CONDITION OF CONCERN

On the driver seat of certain 2010-2011 Mazda3 and 2011 Mazda2 vehicles, the seat height adjustment lifter link may be cracked due to insufficient strength of the lifter link or the lifter link push nuts may be separated. If the vehicle continues to be used in this condition, the seat may exhibit an abnormal noise or rattling. In the worst case, the lifter link may be broken or detached from the seat frame, causing the seat to be inclined and the driver may not be able to maintain an appropriate driving position, increasing the risk of a crash.1

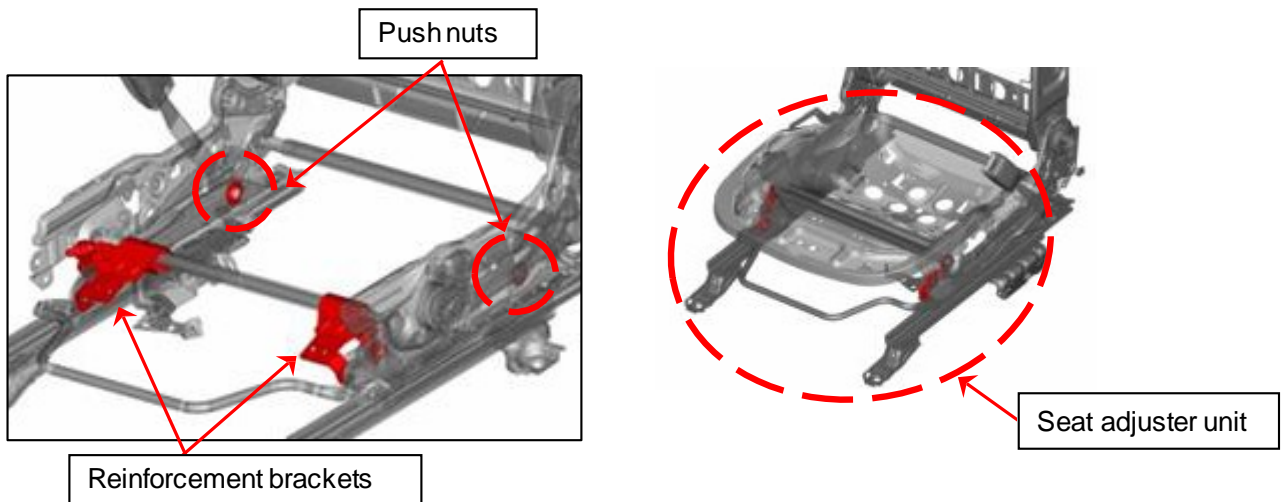
Dealers are instructed to inspect the front lifter links for any crack or damage, and if no crack or damage exists in the lifter links, install reinforcement brackets on the lifter links, and increase the number of push nuts for the rear seat lifter links to two per lifter link.

If any crack or damage exists in the lifter link, the seat adjuster unit needs to be replaced with a modified one. The inspection and repair must be performed on all subject vehicles at no charge to the vehicle owners.
